Deviation From Design

DfD : DfD-0009

**Taran Laval – SAAA Builder 7417
Van's Aircraft RV7 - 73918**

VS Oversize Hole

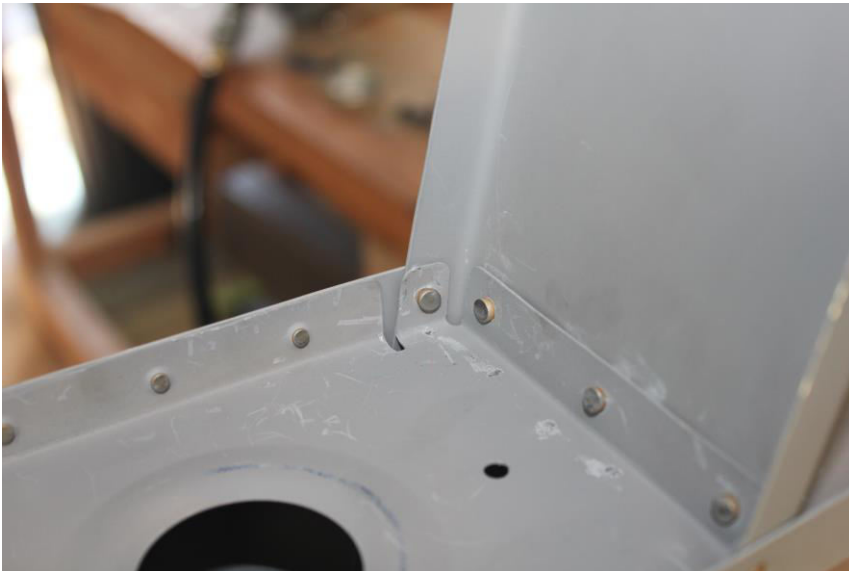
At 702-704-801PP RHS Intersection wrong rivet was installed, in trying to remove wrong rivet hole became oversized

I Elected to Install a NAS109AD4-5 (Oops) Rivet.
